**CITY PLAN COMMISSION****THURSDAY, JANUARY 23, 2025****FILE NUMBER:** S245-047**SENIOR PLANNER:** Hema Sharma**LOCATION:** Cole Avenue, south of Armstrong Avenue**DATE FILED:** December 26, 2024**ZONING:** PD 193 (MF-2)**PD LINK:** <https://dallascityhall.com/departments/city-attorney/Articles/PDF/Article%20193.pdf>**CITY COUNCIL DISTRICT:** 14**SIZE OF REQUEST:** 0.9298-acres**APPLICANT/OWNER:** Tyler Sibley, Kairoi Properties, LLC; Brian O'Boyle Sr., Berryset II Uptown LTN, LLC

**REQUEST:** An application to replat a 0.9298-acre tract of land containing all of Lots 4 through 6 in City Block 1/1531 to create a 12-lot shared access development with lots ranging in size from 0.0563-acre (2,452 square feet) to 0.0922-acre (4,017 square feet) on property located on Cole Avenue, south of Armstrong Avenue.

**PRELIMINARY PLAT**  
**KNOX RESIDENCES ON COLE**  
**SHARED ACCESS DEVELOPMENT**  
**LOTS 1-12, BLOCK 11531**  
BEING A CERTAIN PART OF BLOCK 11531  
WILLIAM B. COATS SURVEY, ABSTRACT NO. 237  
CITY OF DALLAS, DALLAS COUNTY, TEXAS  
ENGINEERING PLAN NO. 3111

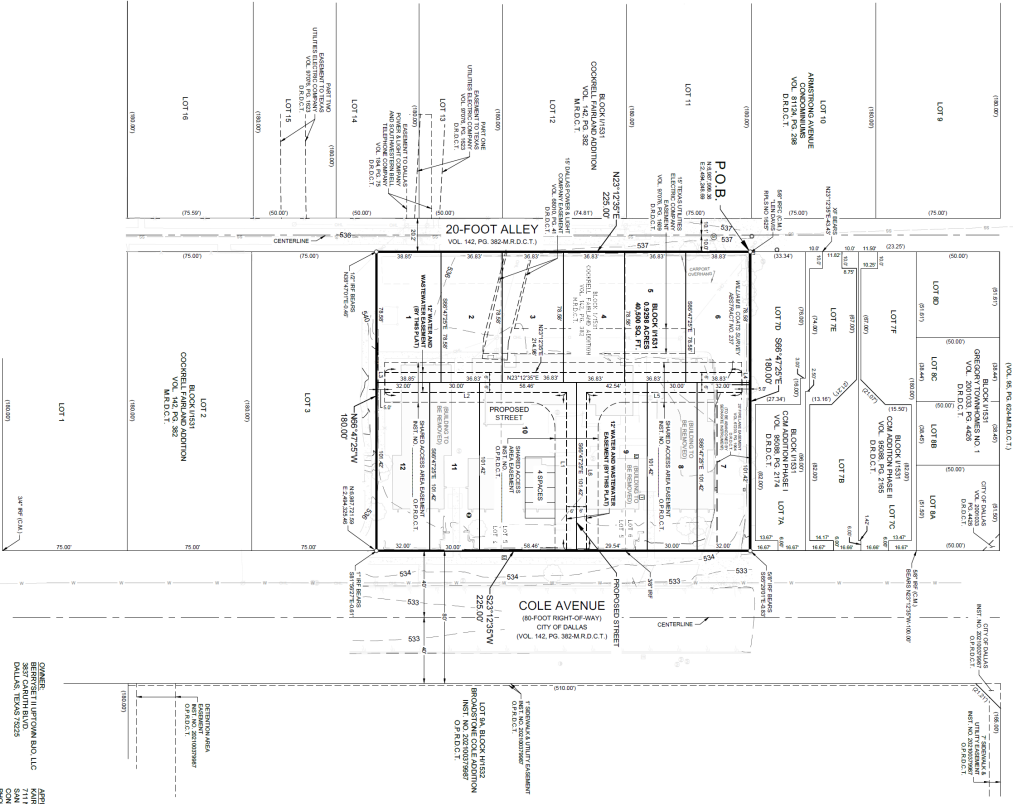
30. Include the words "Shared Access Development" in the title block of the final plat. Platting Guidelines

31. Place a note on the final plat stating: “No vehicular access is permitted to adjacent property outside the platted property from the shared access area except to a public or City Council approved Private Street.” Section 51A-4.411(d)(3), and 51A-4.411(d)(10)
32. If a guard house is provided, it must be at least 30 feet from the shared access point. Section 51A-4.411(d)(8)
33. The Shared Access Area Easement must be terminated a minimum of 3 feet from the adjacent property or right-of-way. Section 51A-8.618(b)
34. Provide guest parking at a rate of 0.25 spaces per dwelling unit and with adequate maneuverability per the Shared Access Development requirements.

39. Prior to final plat, please show the abandonment on the plat as follows: Abandonment authorized by Ordinance No.\_\_\_\_\_, recorded as Inst. No.\_\_\_\_\_.
40. On the final plat, change “Armstrong Avenue (FKA Frank Street)” to “Armstrong Avenue (AKA Armstrong Street FKA Frank Street)”. Section 518.403(a)(1)(A)(xii)
41. On the final plat, identify the property as Lots 1 through 12 in City Block A/1531.
